Model: NAD 30S/30/40		Date: 31-May-98	No: 1
Modified Article: China and Taiwan Version Information		Prepared by: S.Tomoe	
From: Technical Service Department.			
Reason for Modification:	☐ Parts catalog correction ☐ Vendor change ☐ To meet standards ☐ To facilitate assembly ☐ To improve reliability () ☐ Part standardization ☒ Other

The China and Taiwan version will be launched from July 1998. This MB includes parts information for the China and Taiwan version. So, please add this information to your NAD30/40 parts catalog.

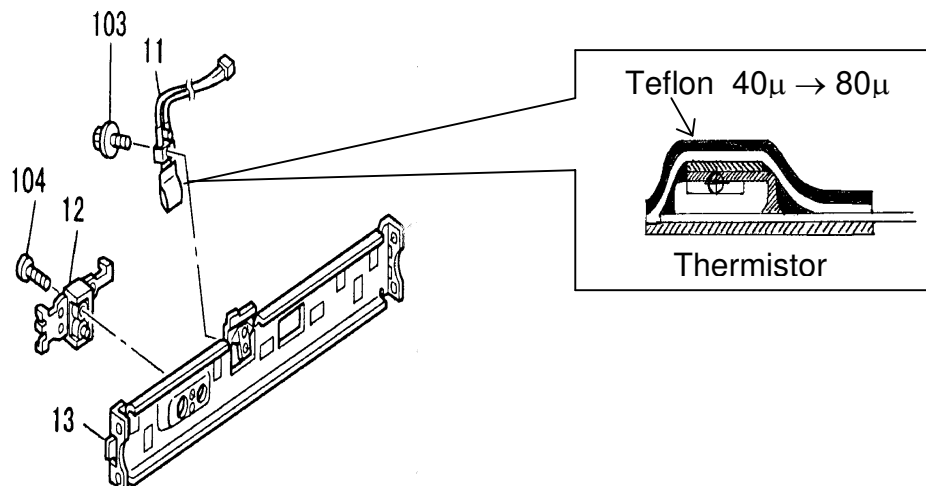
Old	New
Part Number	AW10-0042	AW10-0051
Teflon Thickness	40 μ	80 μ

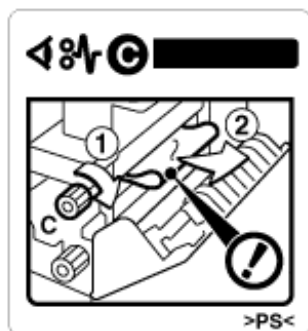
To encourage the customer to open the right cover and check whether misfed paper is still in the fusing section or not, the Jam Removal Decal P/N: A232-1386 has been added as an accessory.

Note: The position of the decal should be on the right cover or on the duplex unit.

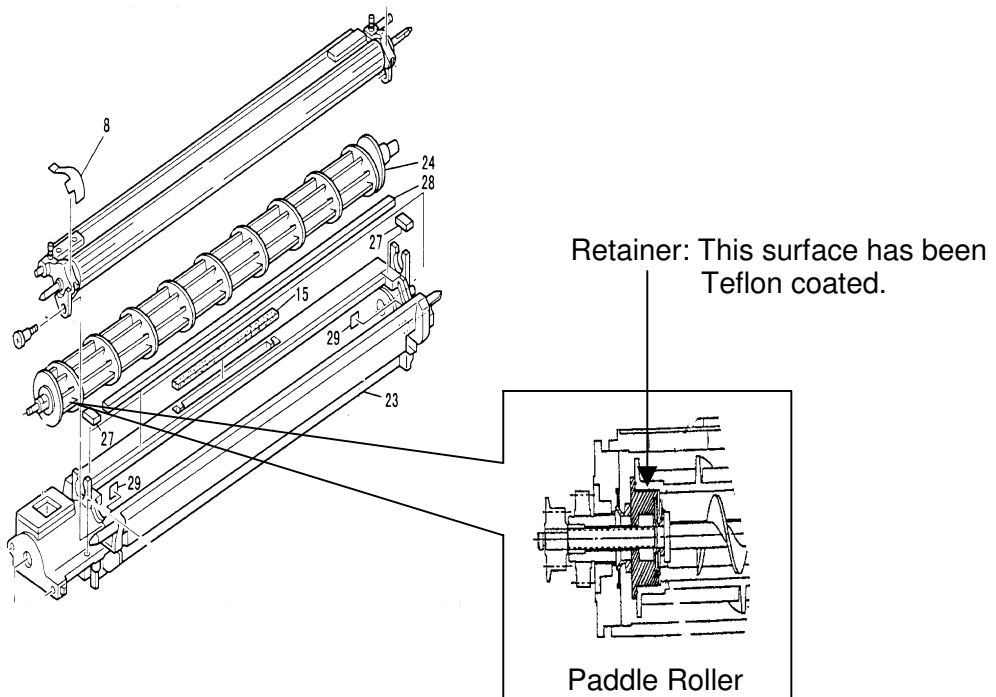
To prevent noise from the development unit, the surface of the retainer in the paddle roller has been Teflon coated. The part number of the development unit has been changed as shown in the table below.(Note: See RTB # 20)

Old part number	New part number	Description	Qty	Int	Page	Index	Note
A232-7660	A232-7460	Development Unit	1-1	X/O	45	1	*

Note:
 Part number for the retainer in the paddle roller
 Old: A232-7660 (not coated)
 New: A232-7460 (Teflon coated)

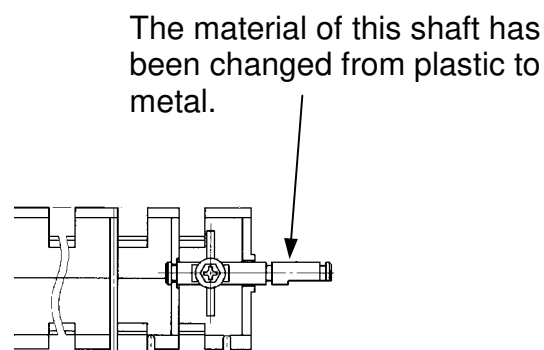
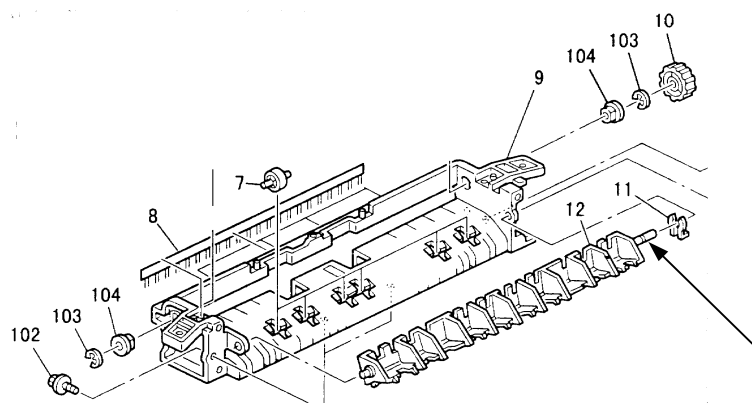
Old part number	New part number	Description	Qty	Int	Page	Index	Note
A232-4467	A232-4452	Entrance Junction Gate	1-1	X/O	49	12	*

To prevent the junction gate shaft from being broken, the material of the junction gate has been changed from plastic to metal. The part number also has been changed as shown below.

Developer Leak Mechanism

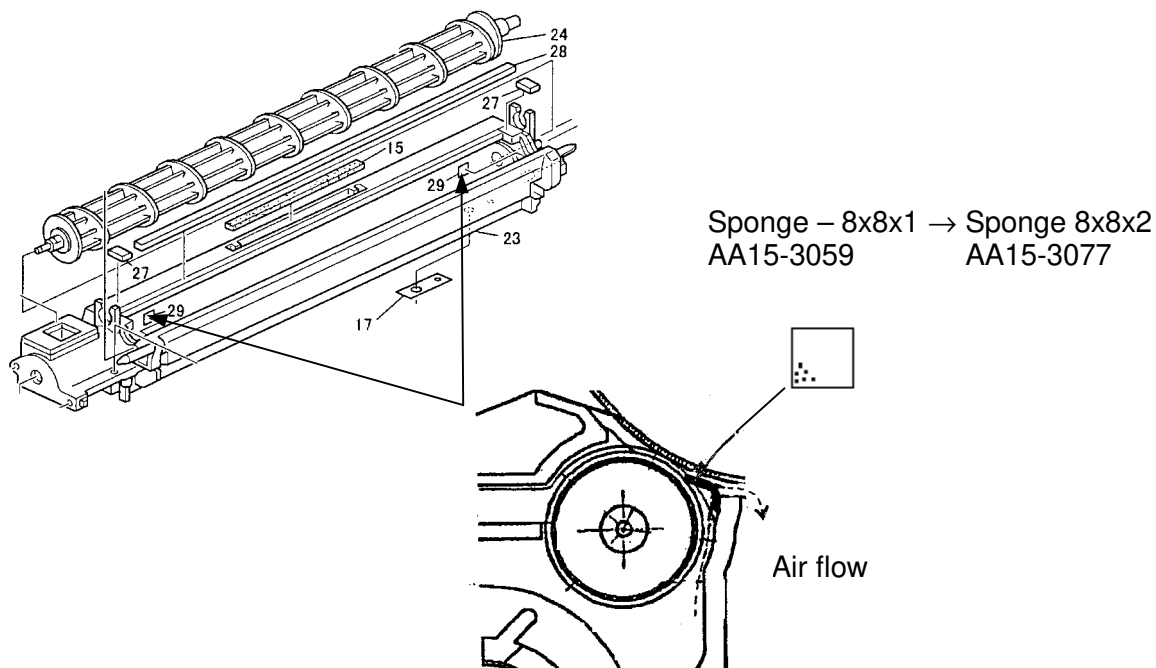
Old part number	New part number	Description (New)	Qty	Int	Page	Index	Note
AA15-3059	AA15-3077	Sponge 8 x 8 x 2	2-2	X/O	45	29

If there is a gap between the sponge seal and the development unit case, air will flow from inside the development unit to the outside. A small amount of developer is pushed out by this airflow. Please refer to the illustration below.

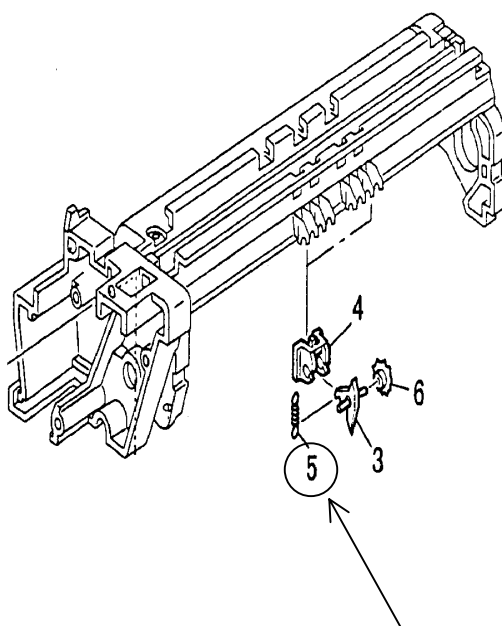
To reduce the wear on the drum caused by the pick-off pawls, the tension of the pressure springs of the pick-off pawls has been changed as follows:

Old part number	New part number	Description	Qty	Int	Page	Index	Note
AA06-2302	AA06-2310	Pressure Spring	2-2	X/O	39	5

Old	New
Part No.	AA06-2302	AA06-2310
Color	Brown	Silver
Tension	5.5mN	4.0mN

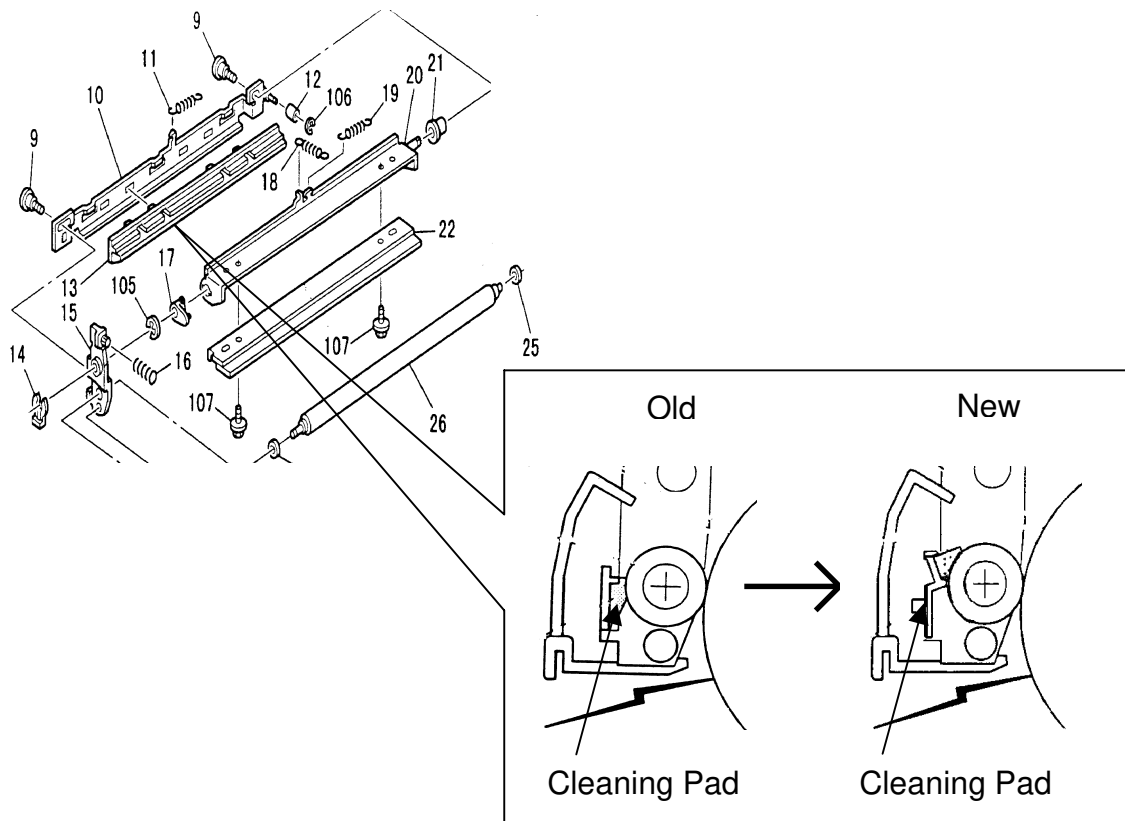
Old part number	New part number	Description	Qty	Int	Page	Index	Note
A232-2301	A232-2430	Cleaning Pad	1-1	X/O	39	13

To prevent the charge roller from vibrating slightly, the shape and position of the cleaning pad have been changed as shown in the illustration below.

Paper Curl Kit: A697-9512

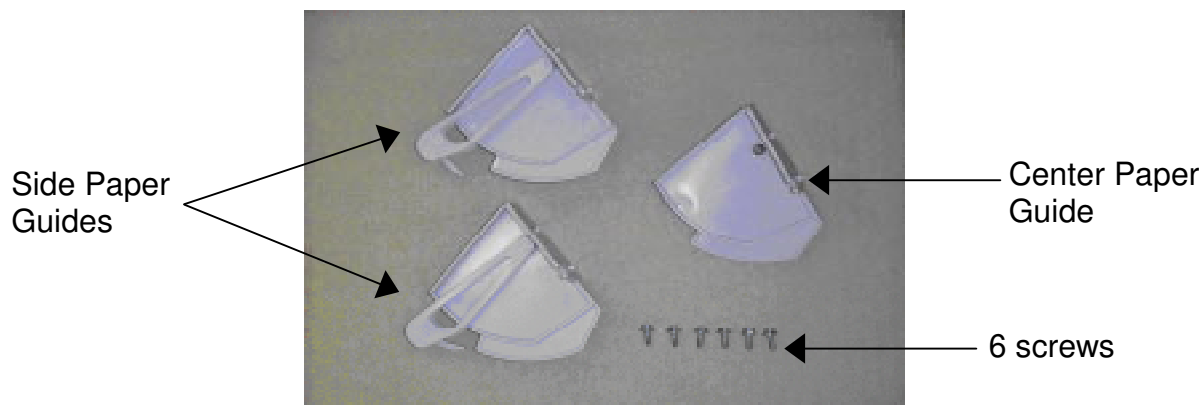
The paper curl kit P/N: **A697-9512** has been registered as a service part. The screw holes for the curl kit have been added to the left upper cover. The part number of the cover has been changed.

Note: This paper curl kit is only for the SR730 installed on the NAD.

Do not use this kit for the SR730 installed on the SP5.

17.TRANSFER UNIT 1 (A230/A231/A232)

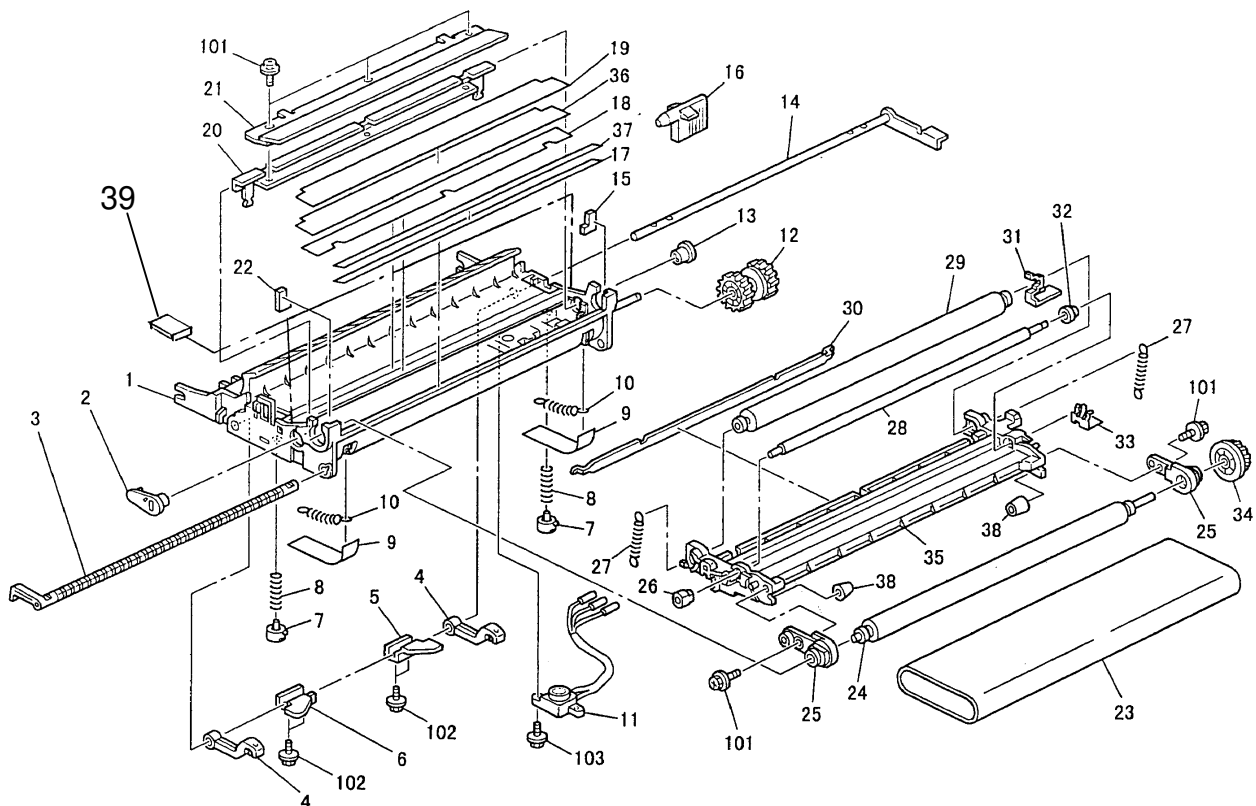
To prevent toner leakage from both sides of the transfer unit, seals have been added to the side plate of the transfer unit.

Old part number	New part number	Description	Q'ty	Int	Page	Index	Note
-	A2323927	Seal – Side Plate	2	-	41	39

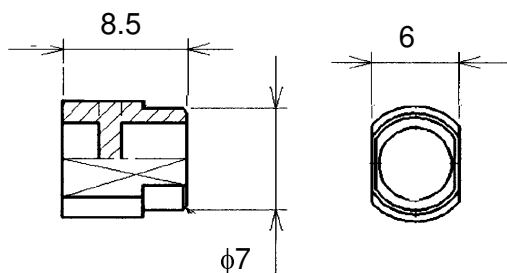
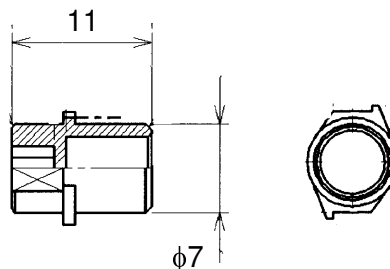
1. The length of the bias roller bushing has been changed from 8.5 to 11 mm.
2. The area where the bias roller bushing is attached has been modified.

Please also note that the name for the transfer belt frame (A2323882) listed in the parts catalog is "Flange – Transfer Unit". This naming has been changed to "Frame – Transfer Belt".

Old part number	New part number	Description	Q'ty	Page	Index
AA080231	AA080246	Bushing – Bias Roller	1	41	26
A2323882	A2323882	Frame – Transfer Belt	1	41	35

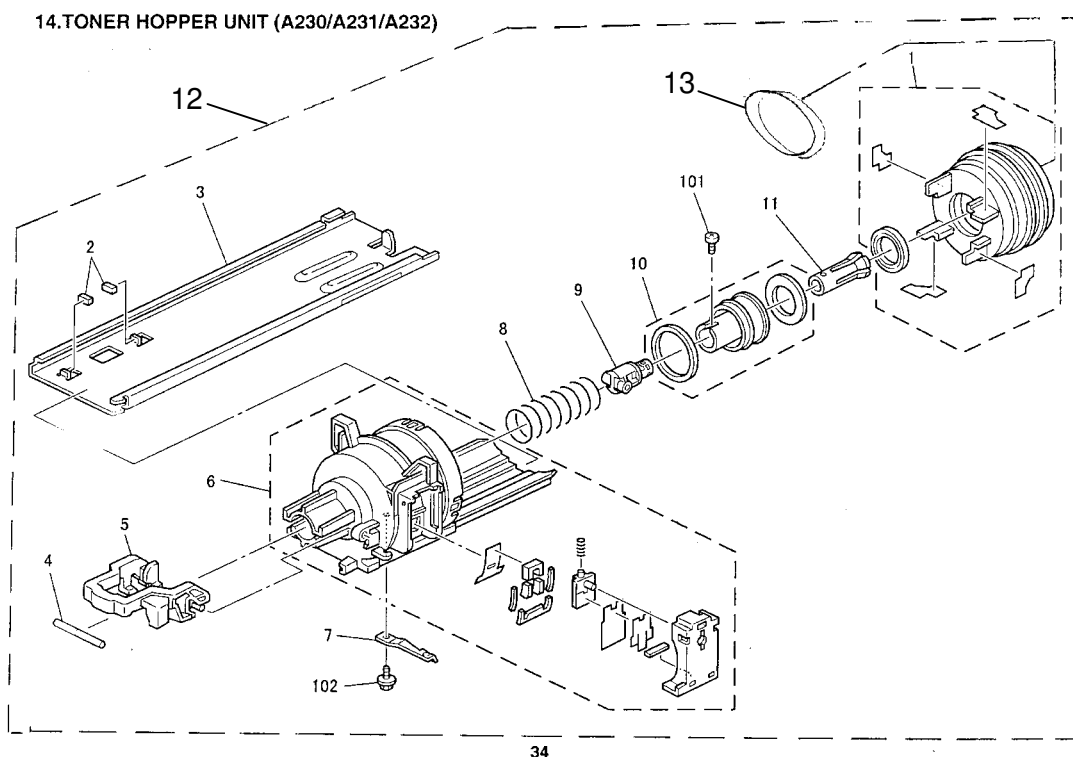
a seal has been added to the inside of the toner supply unit to minimize the freedom of movement of the toner bottle. This will tighten the hold of the toner supply unit on the bottle, preventing any separation of the bottle from the unit.

Old part number	New part number	Description	Q'ty	Int	Page	Index	Note
-	AA153083	Seal – Toner Supply Unit Cover (RIC NA)	1	-	35	13	
-	AA153084	Seal – Toner Supply Unit Cover (RIC EU and OEM)	1	-	35	13

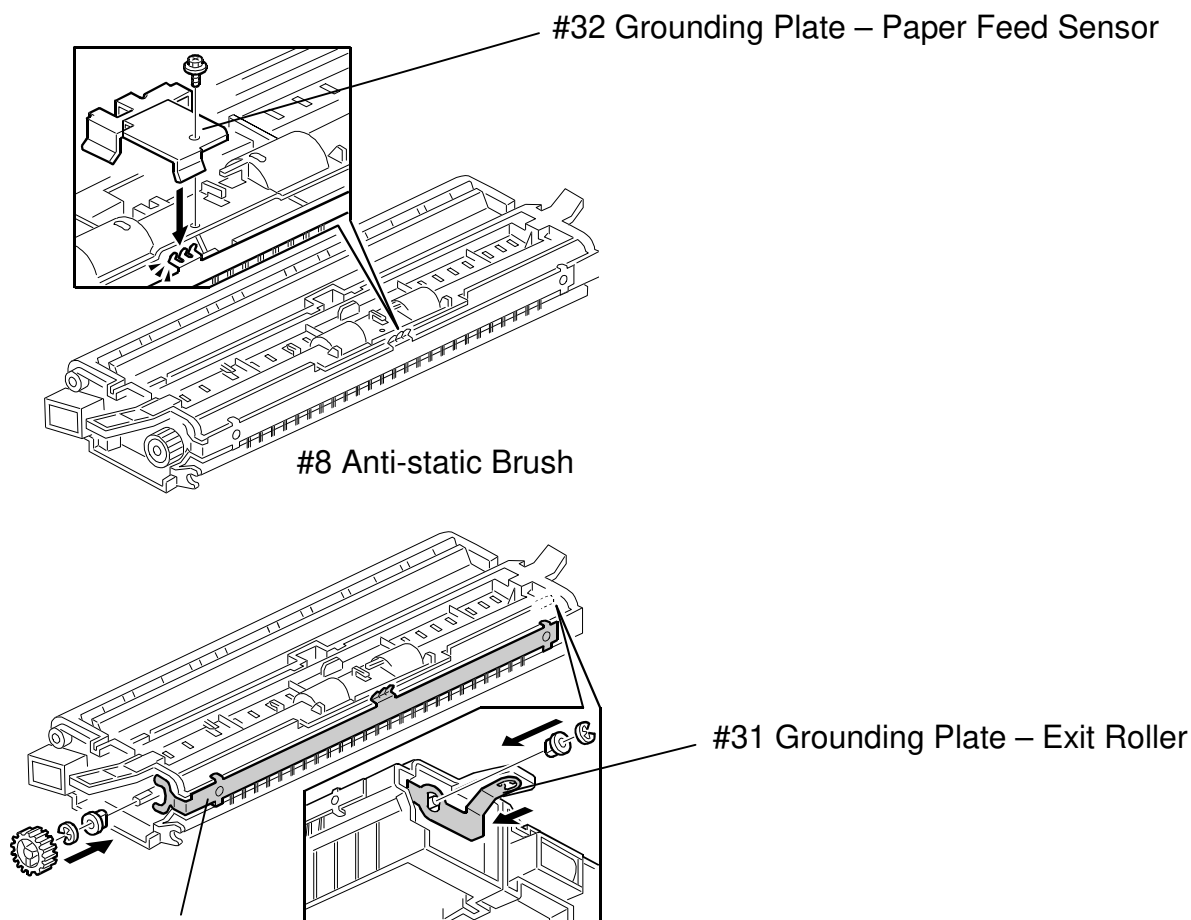
To ensure proper grounding, the shape of the anti-static brush has been changed and grounding plates for the exit and paper feed rollers have been added. Please refer to the illustration below. This modification reduces the occurrences of paper jams caused by static electricity buildup.

25.DRIVE SECTION 1 (A230/A231/A232)

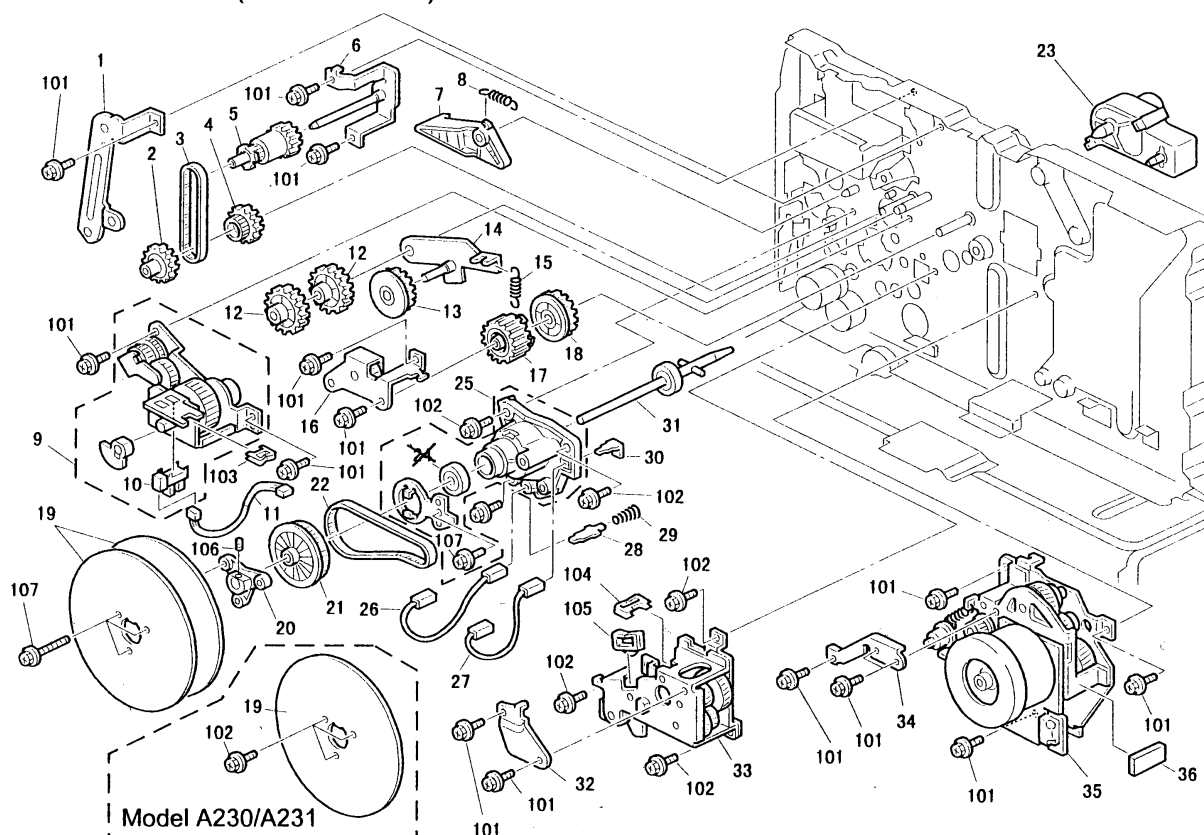
The following part number should be deleted as a service part because the bearing is already press-fit into the Drum Holder itself, and cannot be replaced individually. Therefore, if there is a problem with the holder bearing, it will be necessary to replace the entire Drum Holder (A2327210, index #25).

Old part number	New part number	Description	Q'ty	Int	Page	Index	Note
A2323552		Ball Bearing – 8X22X7	1-0	-	57	24

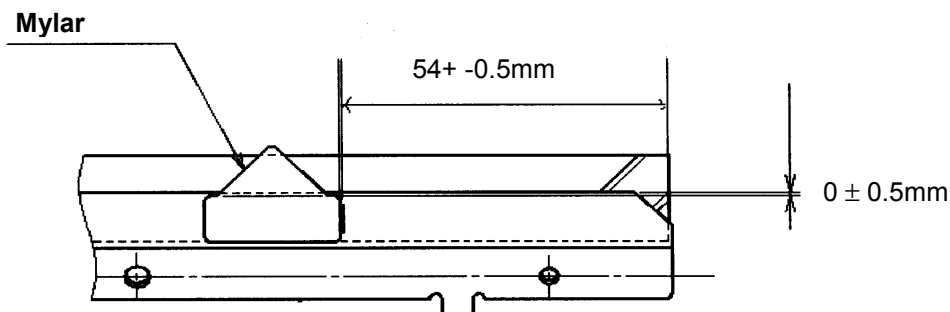
To prevent toner from adhering to the sensor surface in the transfer unit before the case is full, on the back of the cleaning blade a Waste Toner Divider (Mylar) has been added.

Old part number	New part number	Description	Q'ty	Int	Page	Index	Note
A2323930	A2323830	Cleaning Blade – Transfer Belt	1	X/O	41	21

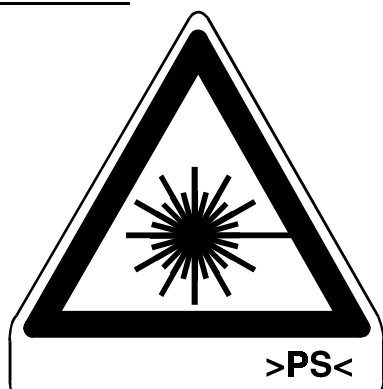
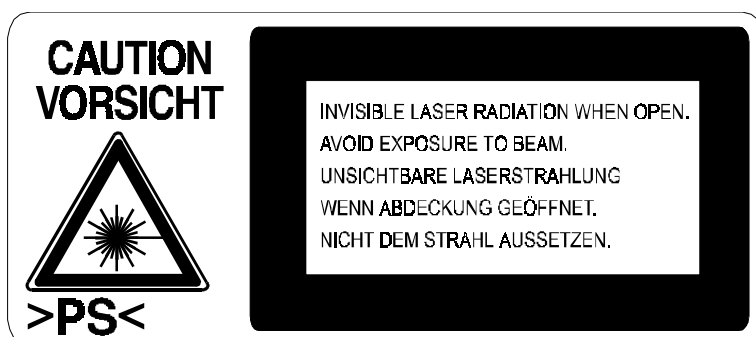
Old part number	New part number	Description	Q'ty	Int	Page	Index
G0201918		Decal - Laser Diode	1-0		23	2
G0201917	G0291980	Decal - LD	1-1	O/O	23	3

Old decals:

New (combined) decal:

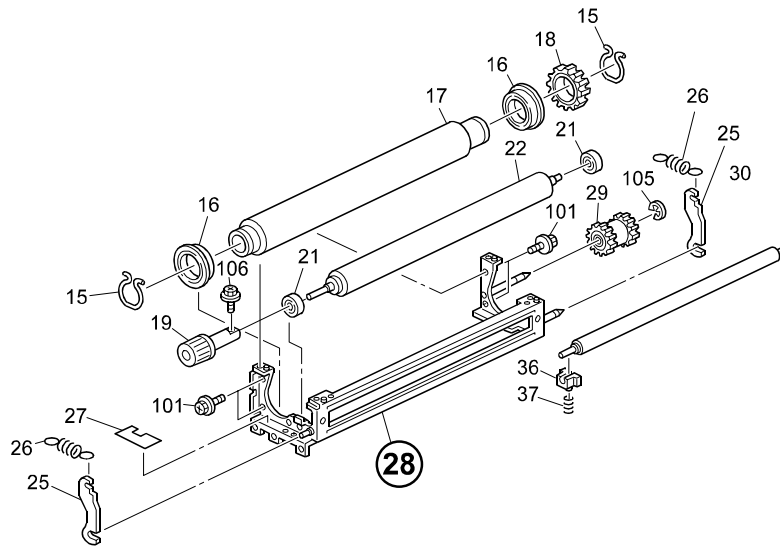
The following has been changed due to a vendor change.

Old part number	New part number	Description	Q'ty	Int	Page	Index	Note
A2324051	B0774051	Frame – Fusing Unit	1-1	O/O	47	28
